# Application for Amendment

<b>NRCB USE ONLY</b>	NRCB Application number	Date Stamp
<input type="checkbox"/> Approval <input type="checkbox"/> Registration <input checked="" type="checkbox"/> Authorization	LA24044A	NRCB APPLICATION 13 JAN 25 RECEIVED

Which permit do you wish to amend? (List permit number and issuing agency.)	LA 24044	
Legal Land Description(s)	NW 6-11-21 W4M	(Qtr-Sec-Twp-Rg-W Mer)

# Catch Basin Storage Volume Calculator

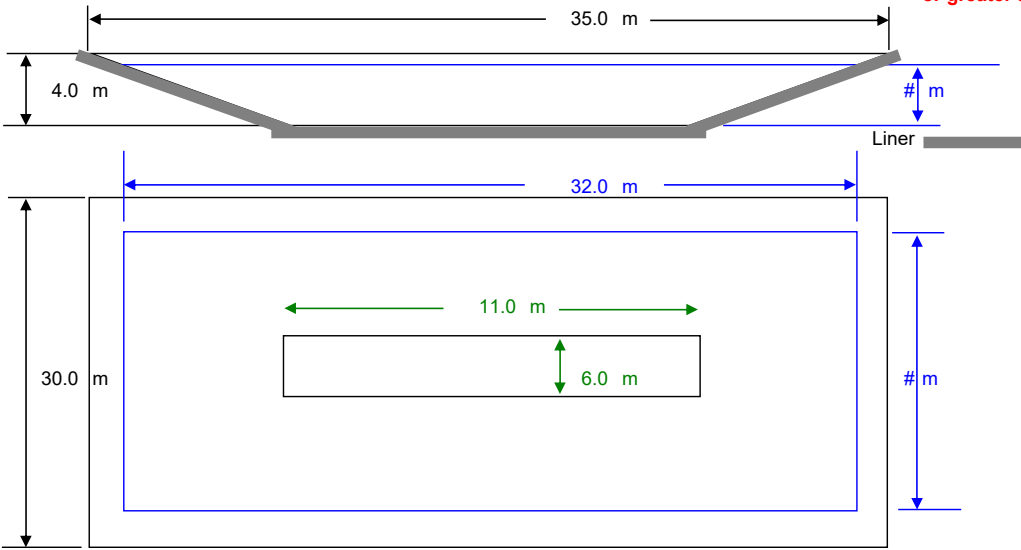
Our permitted catch basin is  $1948\text{m}^3$  (30m x 45m)  
The measurements did not work where we  
wanted to drive with equipment. We wanted to  
change dimensions to 30m x 35m which is  
still above our minimum required storage of  $1012\text{m}^3$   
The location of catch basin is still  
in the same location.

Catch basin calculator. Total volume @ freeboard level: 1370 m<sup>3</sup> Runoff capacity requirements met:  YES  NO

LA24044 determined that the catch basin posed a low risk to surface water and groundwater as new facilities that meet or exceed AOPA requirements are presumed to pose a low risk to surface water and groundwater.  
 The change in dimensions, but same depth, will put the catch basin 5 m closer to Piyami drain. The proposed change still meets the setback to surface water. Therefore, the risk to surface water is still presumed to be low.

Changed dimensions of the catch basin (30 m x 45 m vs. 35 m x 30 m) still meets MDS requirements as the closest neighbouring residence is 570 m away.
